OLB FEEDBACK – 20 DEVORE STREET – ST HELIERS; 9 APRIL 2019

Figure: Aerial photograph of the application sites

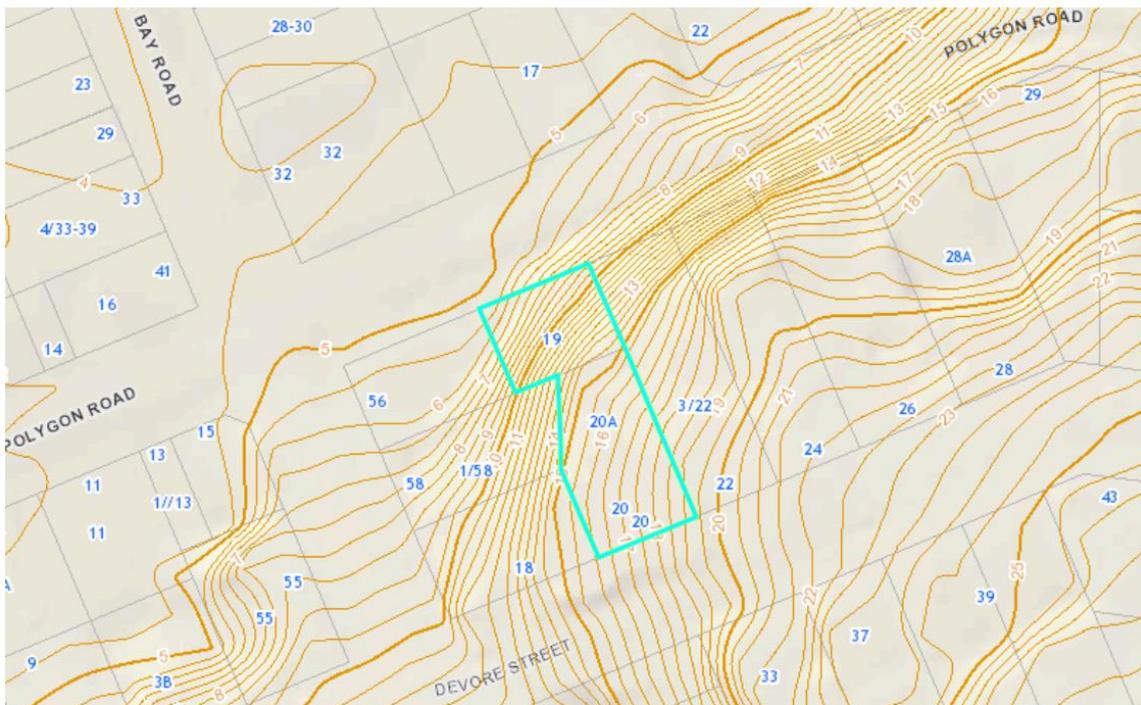
17. Persons at this address are located to the immediate west of the site, adjacent to the footprint of the proposed apartment building. This site occupies a lower ground level than the subject site, by approximately 2m, sloping from the east to west. Accordingly, it is acknowledged that the proposed building has the **potential to have adverse dominance effects** on persons at 18 Devore St, given the location of the apartment building at a higher elevation than persons on this site
